Villa No. 55

Description		Owner & Developer :	
MIRYALGUDA : TYPE - A1 (SIMPLEX)		Modi Properties Pvt. Ltd.	
WORKING DRAWINGS - SHOWING RAILING POSITION		Project Name & Phase :	
		AVR Gubmhar Homes

Villa NO. 56 (A1-23412)

Description	Direction	Owners & Developers:	Date:	13/08/2019	Promoted by
VILLA NO.S 62, 63 & 64 : BATHROOM DETAILS	N	Modi Properties Pvt Ltd. Project Name & Phase : AVR GULMOHAR HOMES	Prepared By : Approved By : Scale :	Soham Modi N.T.S	Modi Properties Pvt. Ltd. Phone:+91-40-66335551

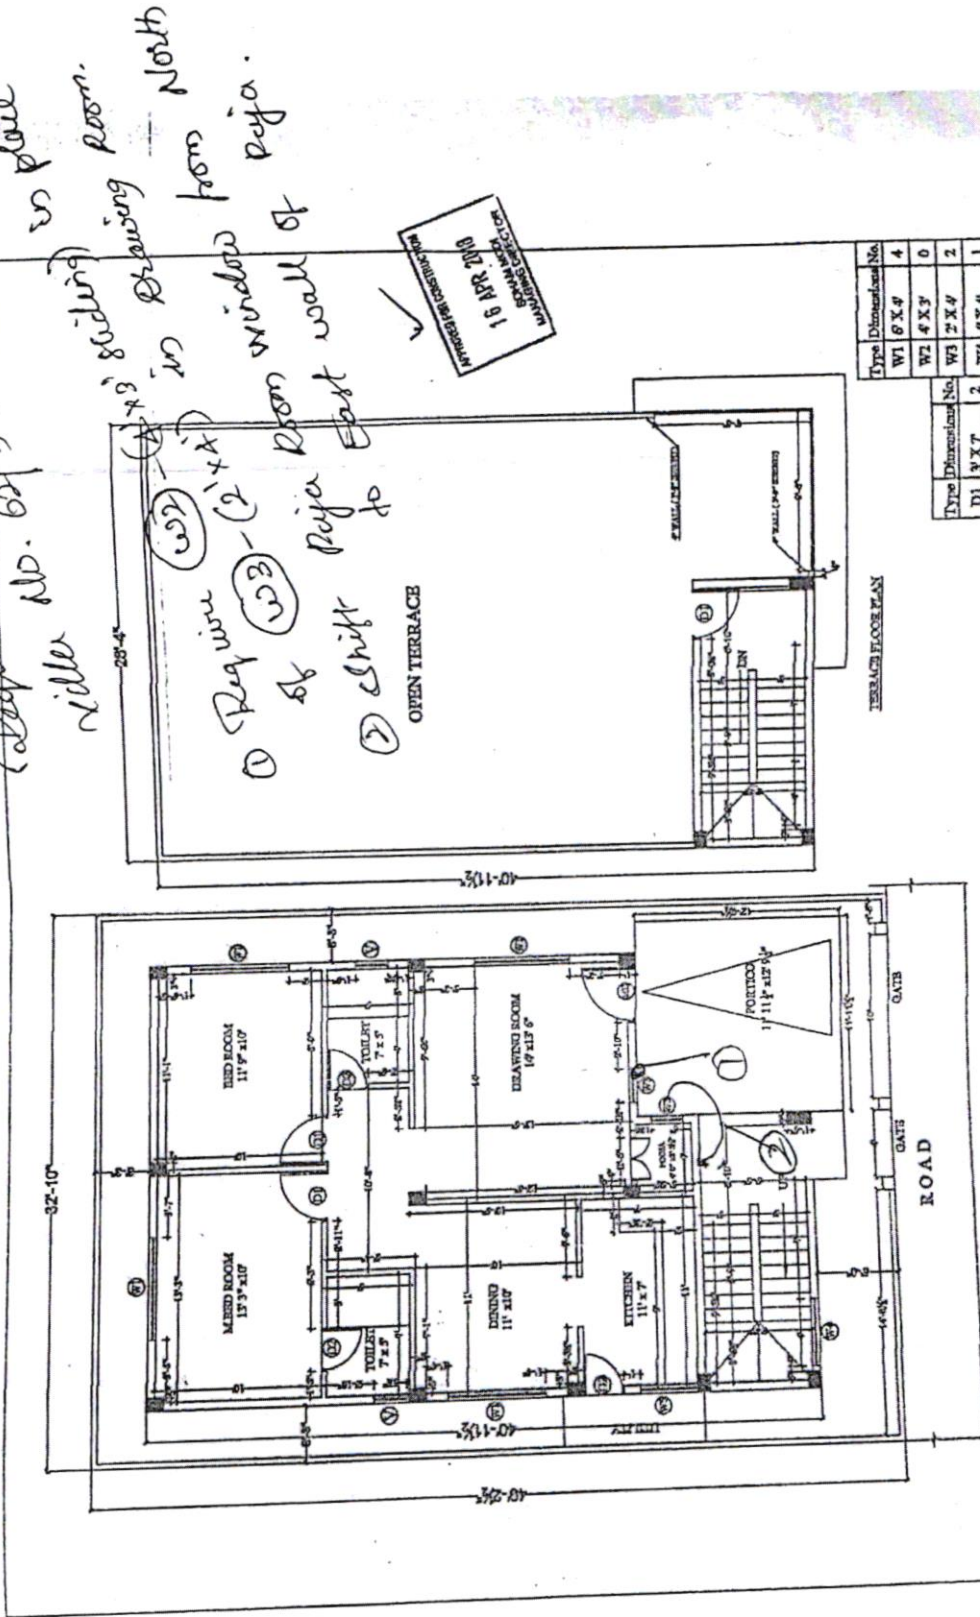
Revised as per this drawing

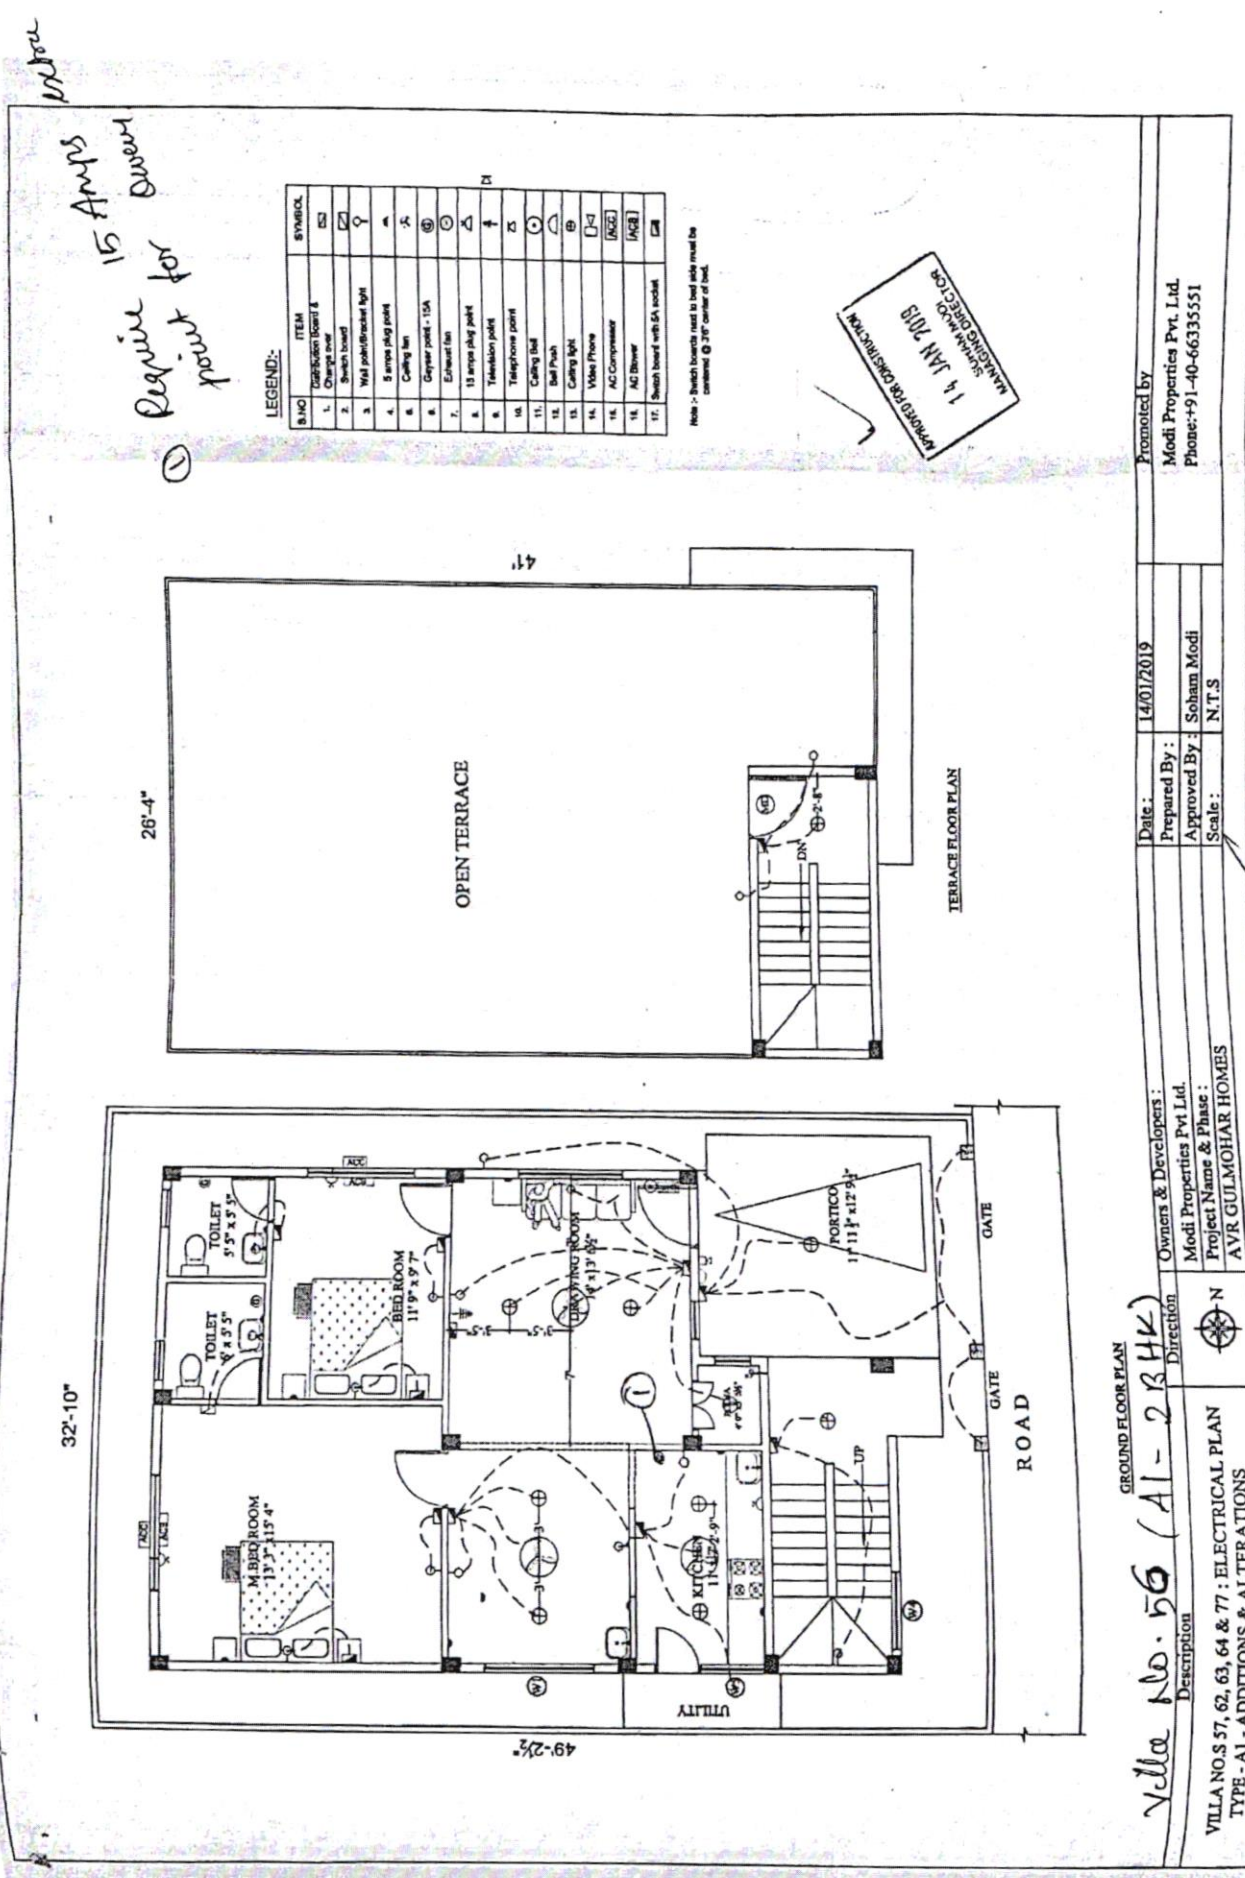
15 Amps
 Require for power
